MEETING NOTICE AND AGENDA
TECHNICAL ADVISORY COMMITTEE
OF THE
SEASIDE BASIN WATER MASTER

DATE: Wednesday, March 11, 2015

| <u>Agenda Item</u> | <u>Page No.</u> |
|---|-----------------|
| 3. Peer Review of HydroMetrics Laguna Seca Subarea Modeling Work | |
| A. Presentation of Draft Peer Review Technical Memorandum (Gus Yates) | 6 |

Figure 25: Western LSSA Impacts from Changes in Outside Pumping – Monitoring Well FO-04 Deep

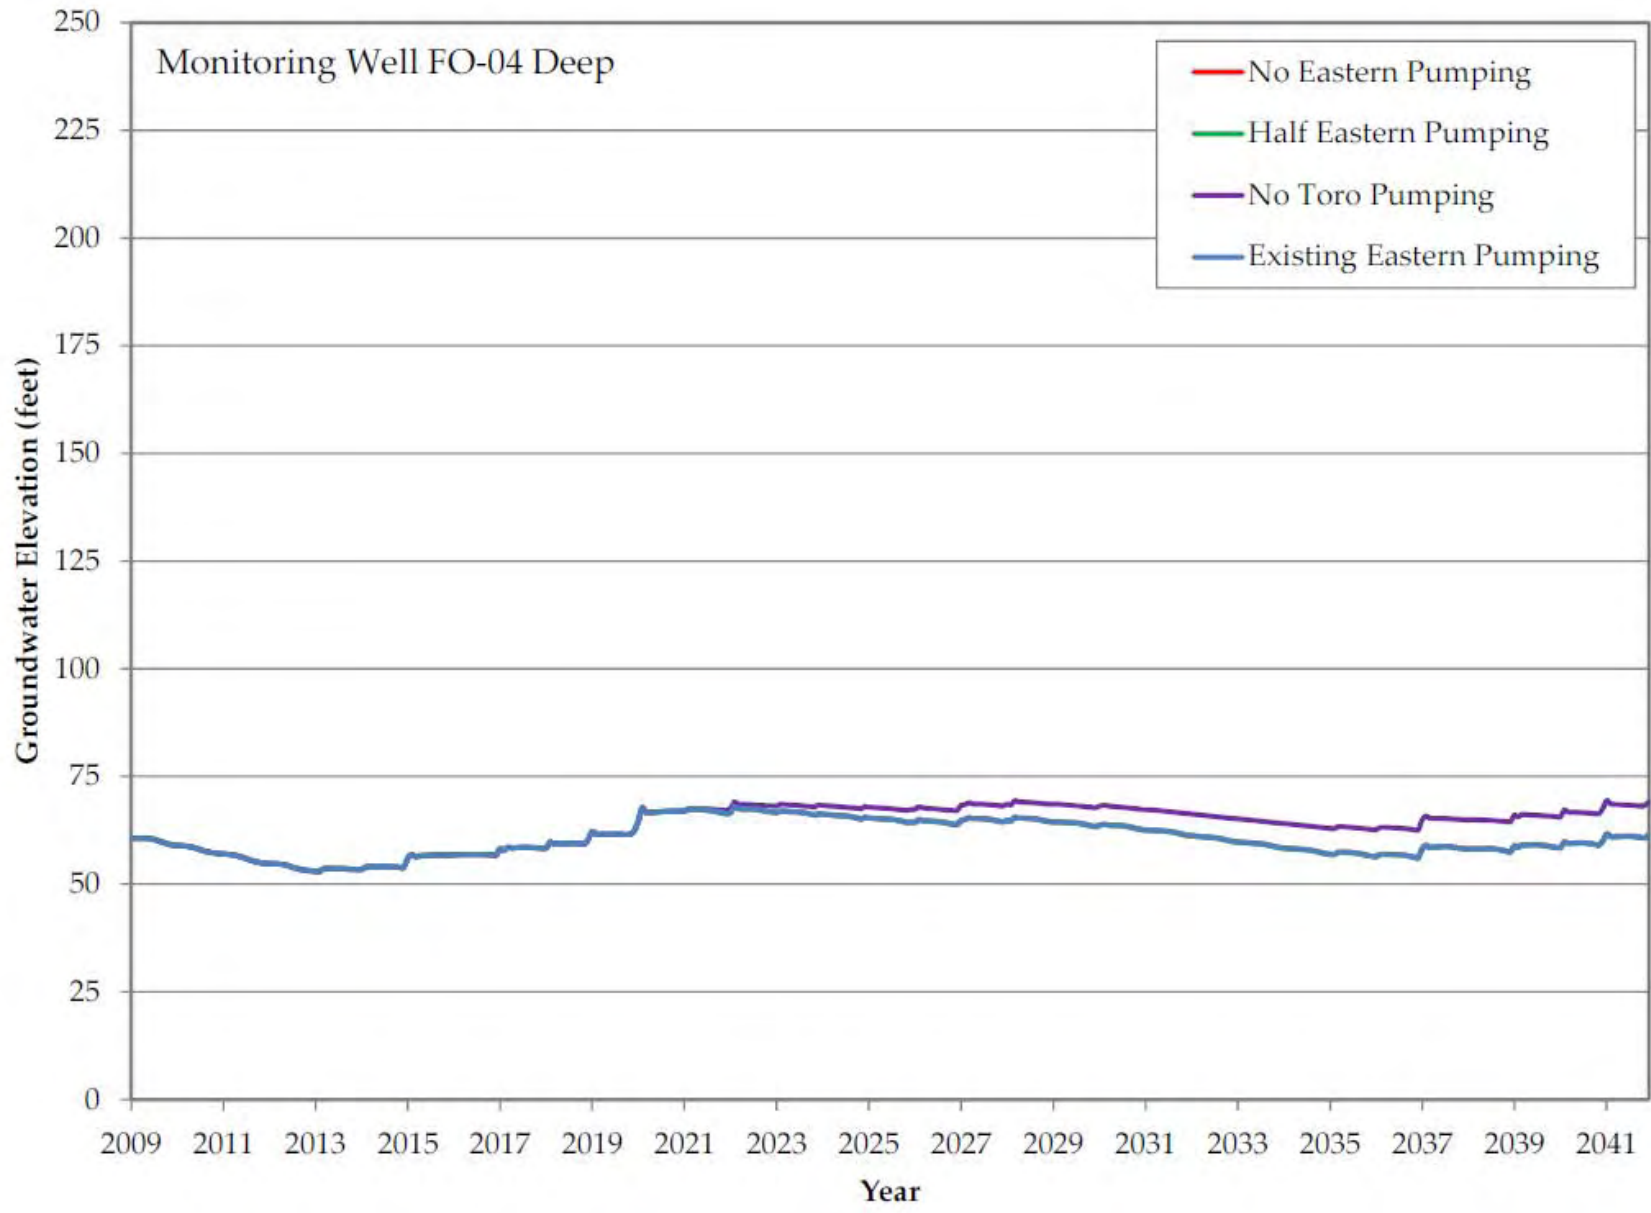
Figure 25 shows that reducing pumping south and east of the LSSA has only a minor impact on monitoring well FO-04 Deep. This monitoring well is the farthest from the outside pumping wells, and is expected to have the least impact from the simulated pumping changes. Similar to the results in Subtask 1.4, groundwater elevations in monitoring well FO-04 Deep do not appear to exceed a certain elevation, regardless of the pumping scenario.

Figure 26: Central LSSA Impacts from Changes in Outside Pumping – Laguna Seca Driving Range Well

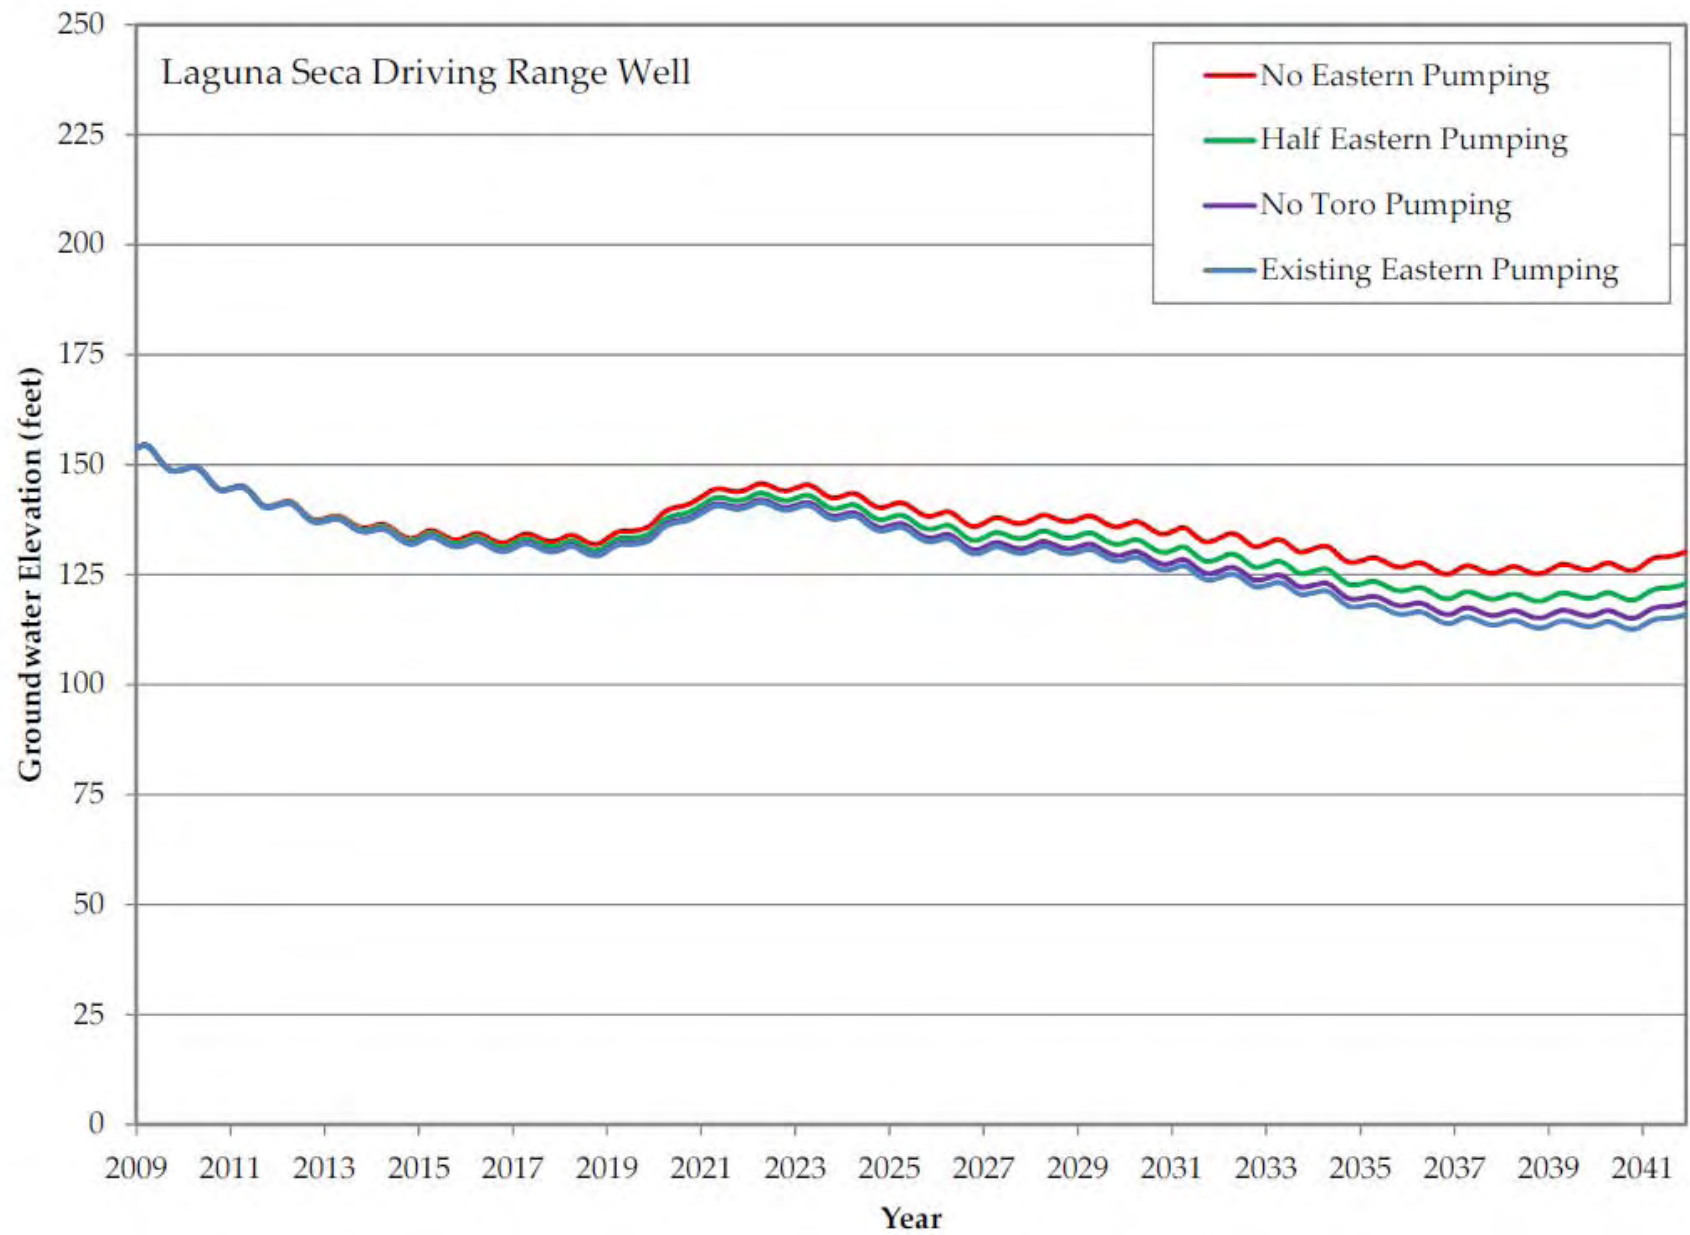
Figure 26 shows that reducing pumping south and east of the LSSA has a small but discernible impact on the Laguna Seca Driving Range well in the central LSSA. None of the four scenarios run for this subtask had enough effect on the Laguna Seca Driving Range well to completely eliminate long-term water level declines. The impact in this area from reducing pumping south and east of the LSSA was notably less than the impact from reducing Alternative producer pumping.

Figure 27: Eastern LSSA Impacts from Changes in Outside Pumping – Monitoring Well FO-06 Shallow

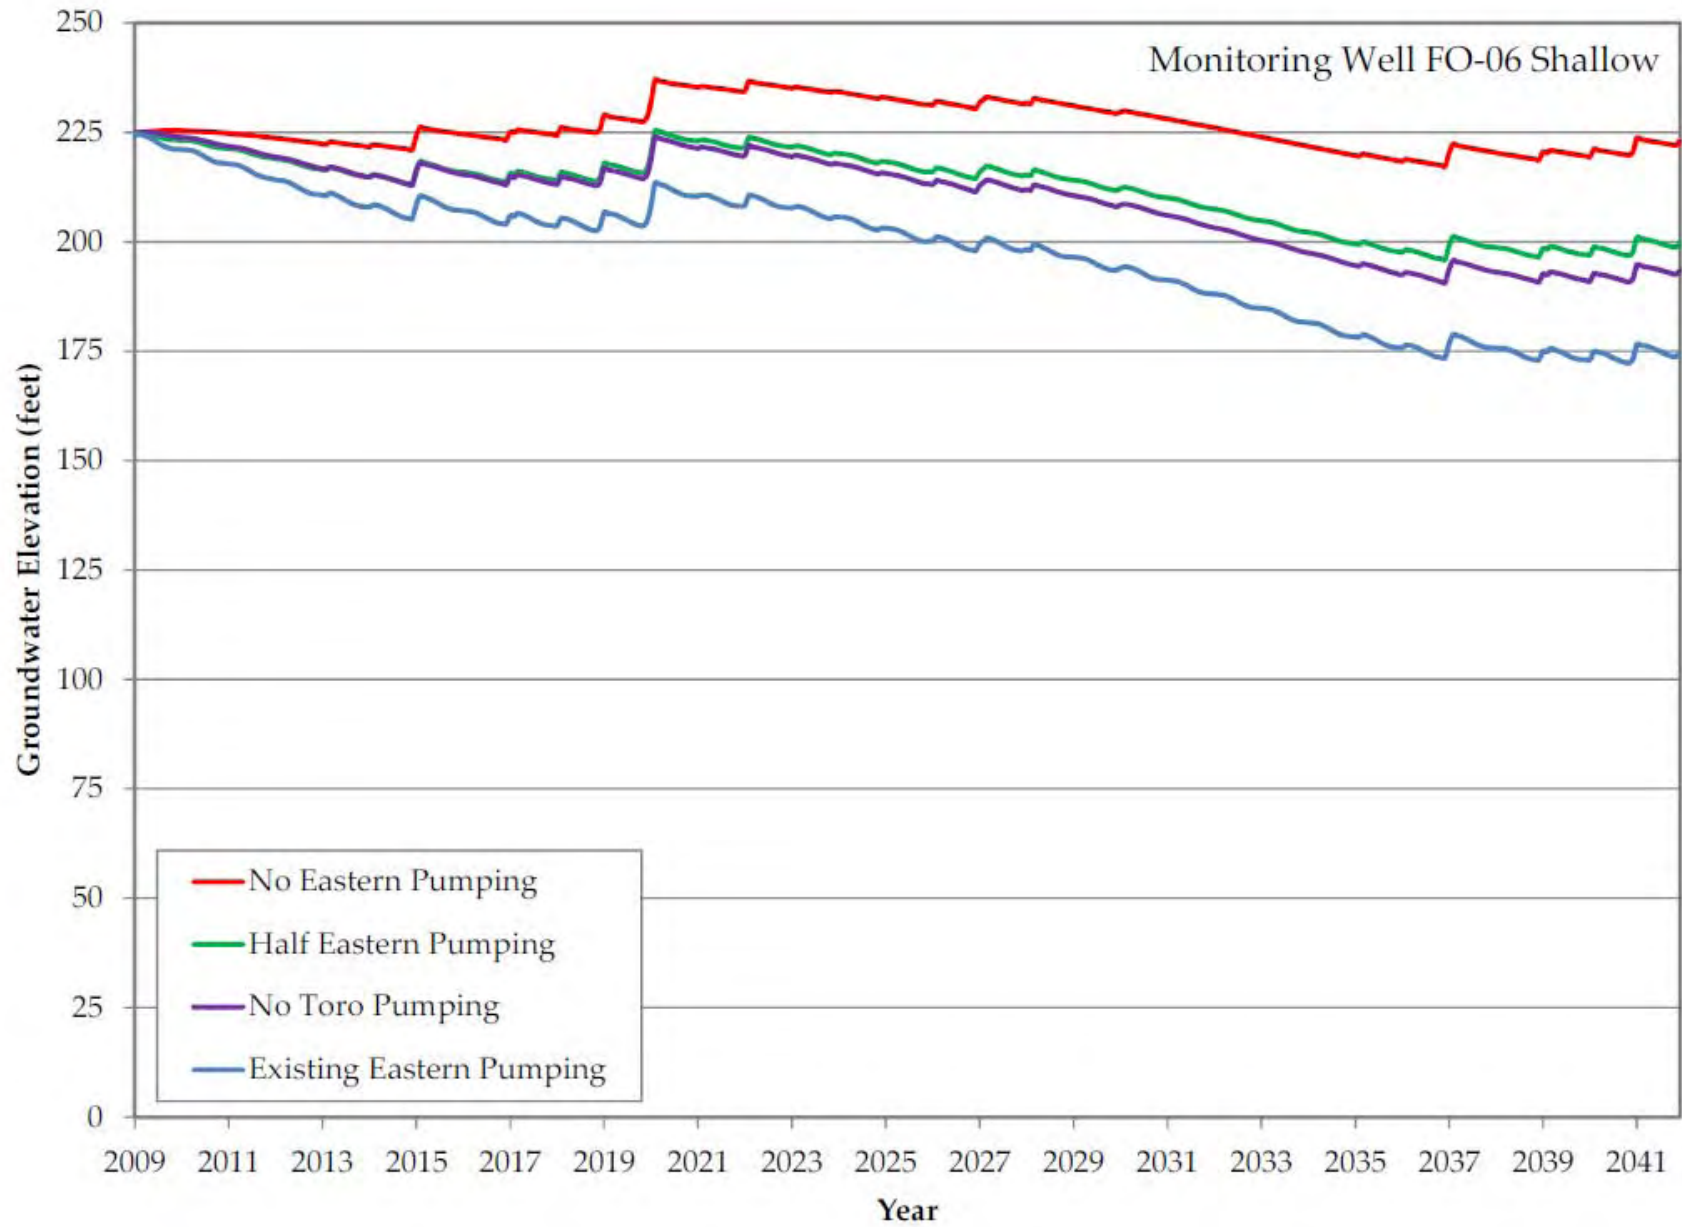
As expected, reducing well pumping south and east of the LSSA has a significant impact on groundwater levels in the eastern portion of the LSSA. This is shown in the hydrograph of monitoring well FO-06 Shallow on Figure 27. In this portion of the subarea, reducing outside pumping or eliminating Toro well pumping has a similar impact. However, to completely eliminate declining water levels in this area, all pumping from wells south and east of the LSSA must be eliminated.
